STATE OF HAWAII
DEPARTMENT OF TRANSPORTATION
HIGHWAYS DIVISION

ADDENDUM NO. 1

**INTERSTATE ROUTE H-1 AND H-201
DESTINATION SIGN UPGRADE / REPLACEMENT, PHASE 3
DISTRICT OF HONOLULU, ISLAND OF OAHU
FEDERAL-AID PROJECT NO. NH-0300(144)**

January 9, 2023

**SIGN STRUCTURE HIEBR-253
RAMP NW @ STA. 51+65**
Scale: 1"=10'

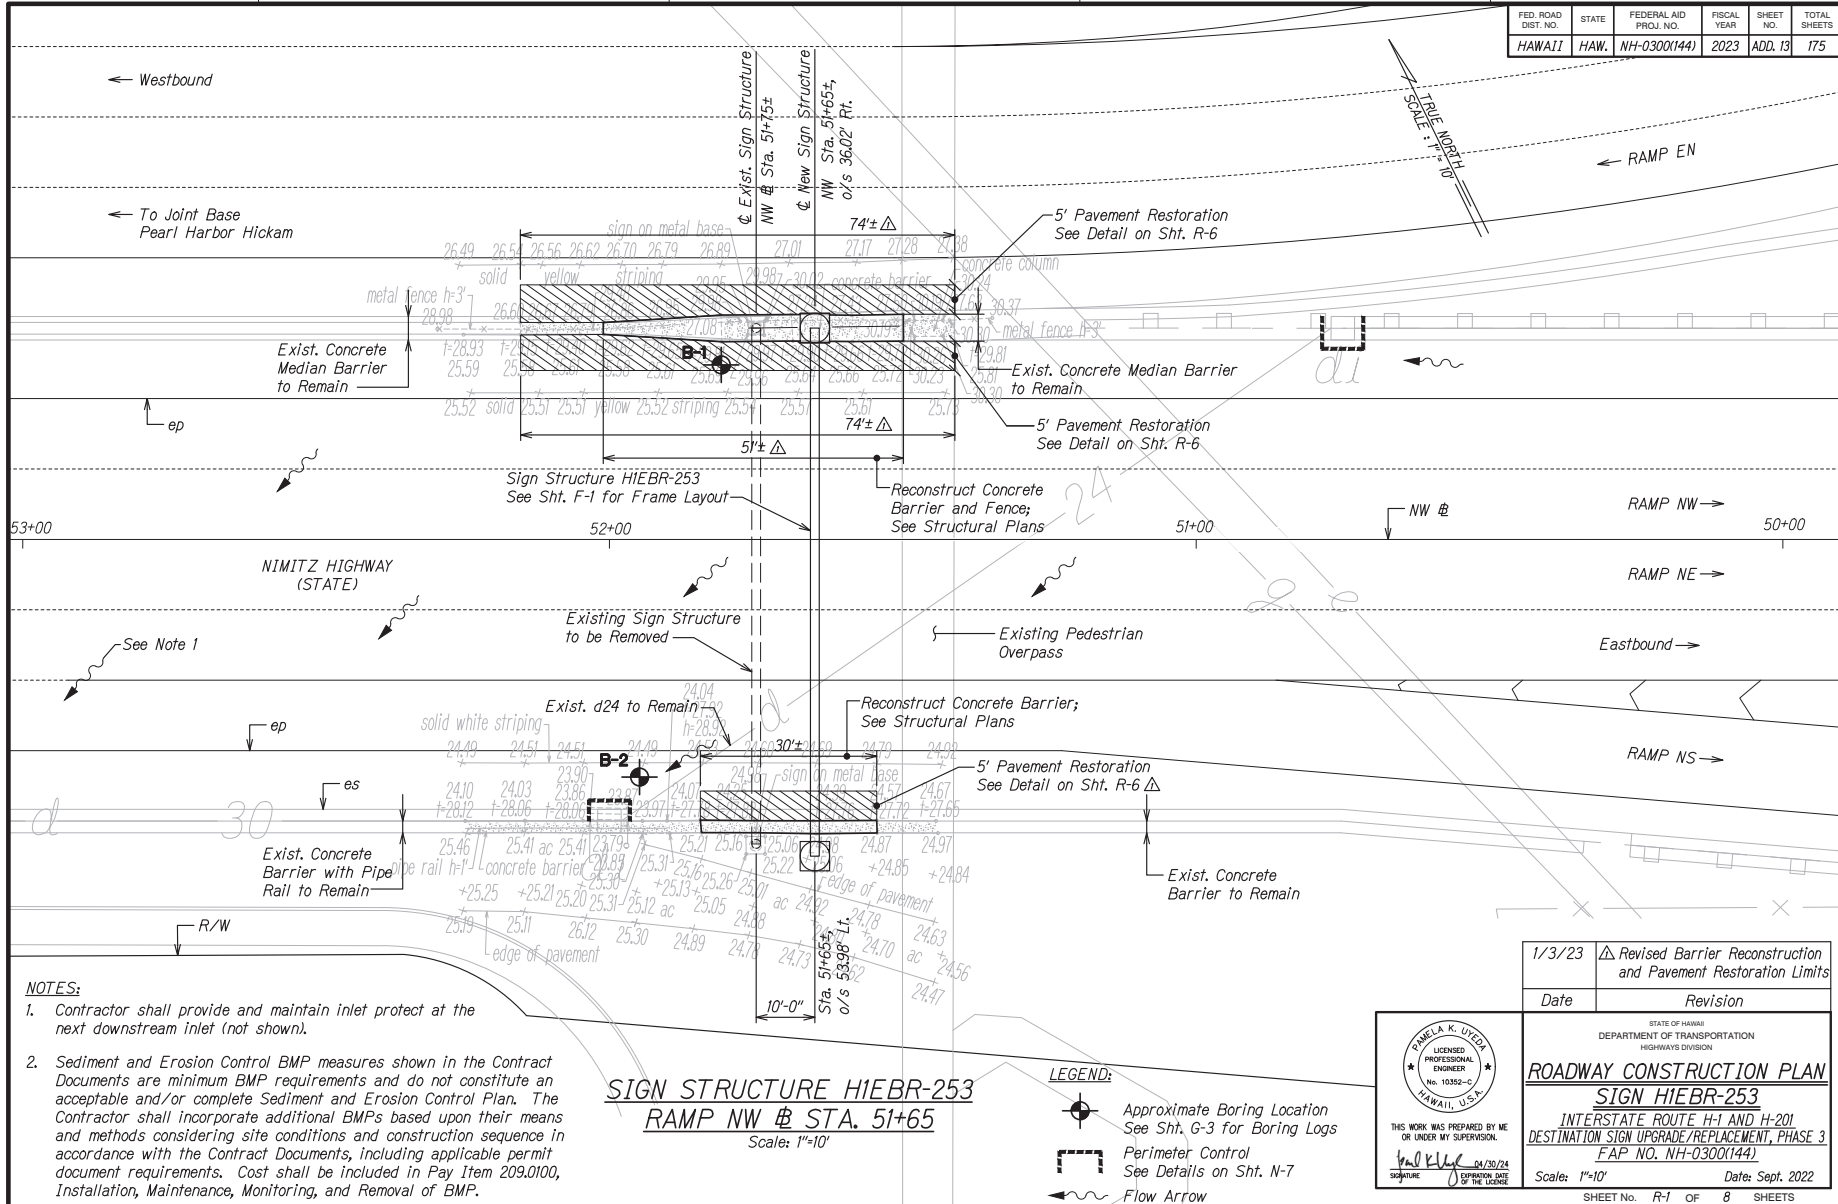
1/3/23	△ Revised Barrier Reconstruction and Pavement Restoration Limits
Date	Revision
STATE OF HAWAII DEPARTMENT OF TRANSPORTATION HIGHWAYS DIVISION ROADWAY CONSTRUCTION PLAN SIGN HIEBR-253 INTERSTATE ROUTE H-1 AND H-201 DESTINATION SIGN UPGRADE/REPLACEMENT, PHASE 3 FAP NO. NH-0300(144)	
Scale: 1"=10'	Date: Sept. 2022
SHEET No. R-1 OF 8 SHEETS
